Re: Proposed development of 26 no. wind turbines and associated works.
at the Ballivor Bog Group, Co. Meath and Co. Westmeath.

Subject: Bord Pleanála Case reference: PA25M.316212

Proposed Ballivor Wind Farm, Co. Meath & Co. Westmeath

Additional comments on "Response to Observations Received" (document file name 191137-o - Submissions Response - D1- 2023.07.14)

Figure 3: Noise Survey Location B at house H125

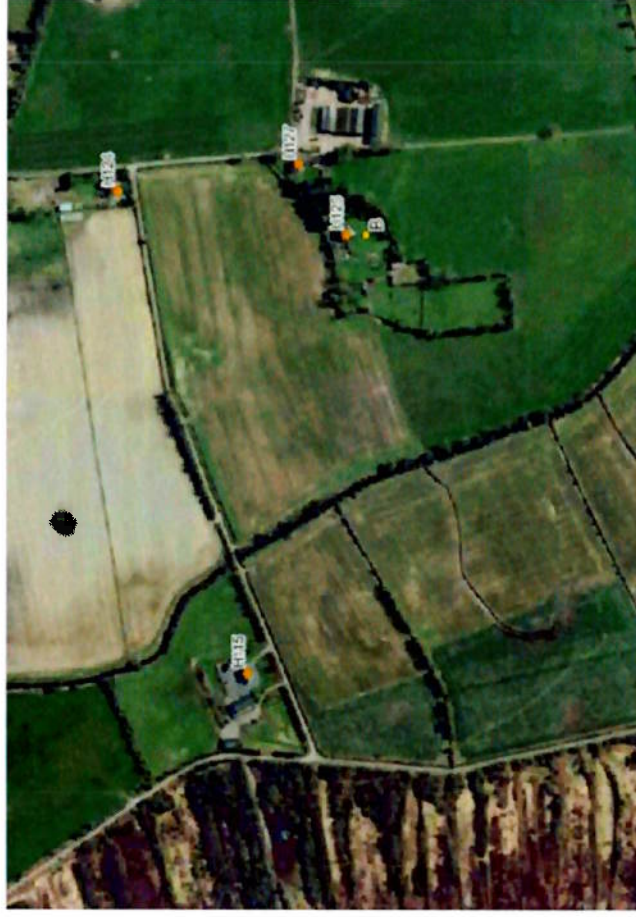
A single assessment at 4m above ground level is approximately ceiling level in our reception area. Our bedrooms are above this level on two further floors.

Screening by trees will have no significant mitigating effect as described in the previous comment.

Mapping of Survey Location H125 and Status of Property. The residents at H125 write that they facilitated a background noise survey in the grounds of their house, but that the location of this noise survey is not correctly reported in the EIAR. Table 11.4 of the EIAR incorrectly reports the noise survey location to be H115 with coordinates E666,471 N759,713 whereas the correct house reference is H125, and the correct coordinates are E666,983, N759,576. The correct monitoring location is shown in Figure 3 below.

It is confirmed that the analysis of the data recorded at this location and presented in the Chapter 11 of the EIAR considered the correct noise survey position, shown as 'B' in Figure 3 below.

The residents at H125 make reference to the circumstances of the building itself as a protected structure in particular the age and height of the building and that this was not factored into the noise assessment. Noise predictions in the EIAR were made at 4m height above ground level for all locations as this is the calculation methodology recommended in the Institute of Acoustics (IOA) document entitled 'A Good Practice Guide to the Application of ETSU-R97 for the Assessment and Rating of Wind Turbine Noise' (IOA, 2013). The methodology outlined in this guidance is used for the assessment of wind turbine noise and represents best practice i.e. No allowances are made in the calculation of the predicted noise levels for screening by trees or other vegetation etc.

Photo taken from roof window on bedroom floor
12/02/24
Facing southwest towards proposed site

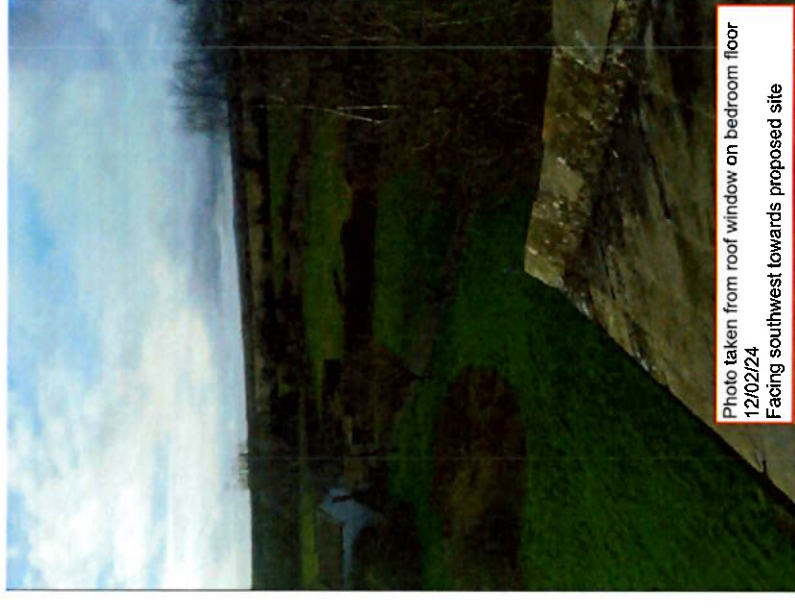
There are very few trees between our property and the turbines (due to the nature of previous land use for turf production and farmland). There is no screening effect provided by trees. We have attached a photograph on the following page showing the view towards the proposed turbines taken from a roof window on our bedroom floor.

The house is at the highest point on our property. Screening by trees will have no significant mitigating effect as the trees are mostly low level, do not surround the house in the direction of the turbines, and are typically lower than the bedrooms of the house. The hedgerow species are predominantly ash and are suffering badly from ash dieback disease so cannot be relied upon into the future for any screening.

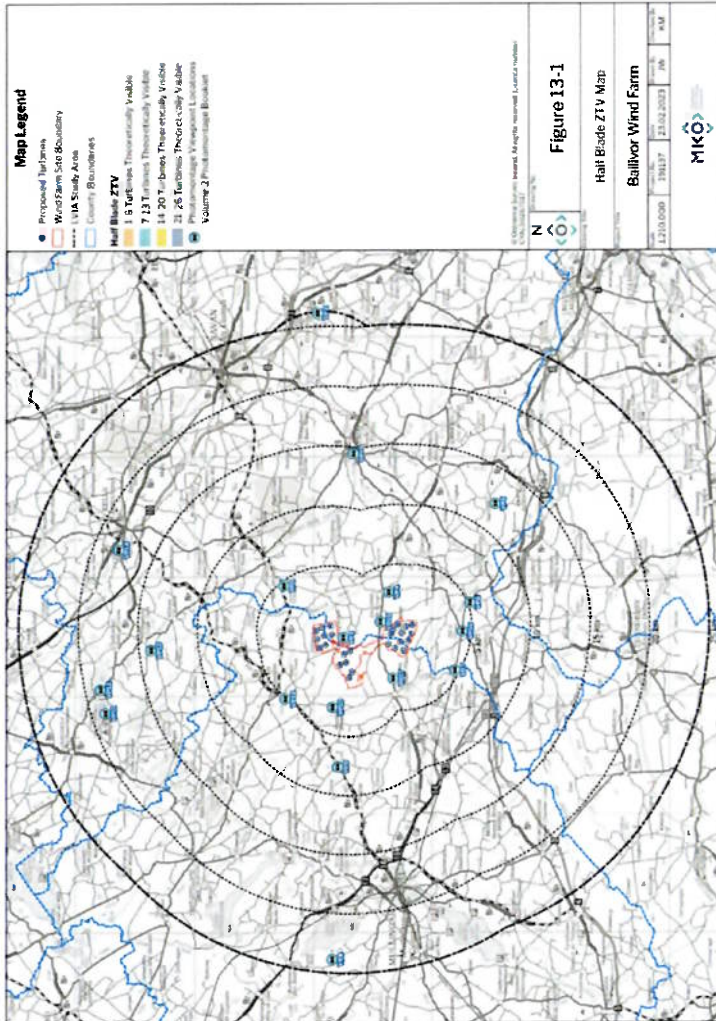
The reproduced map in the "Response to Observations Received" has no colours of zones i.e. the same errors as the original EIAR. Therefore no ZTV map is available.

Section 13.3.1 of the EIAR emphasises that the ZTV is an important part of the LVIA process, yet the error has been repeated in the response.

Due to a digital malfunction, the colours of the Zone of Theoretical Visibility (ZTV) were absent in the ZTV map - Figure 13-1 of the EIAR which is reinserted below. The Applicant has reproduced this map below with the ZTV colours included.
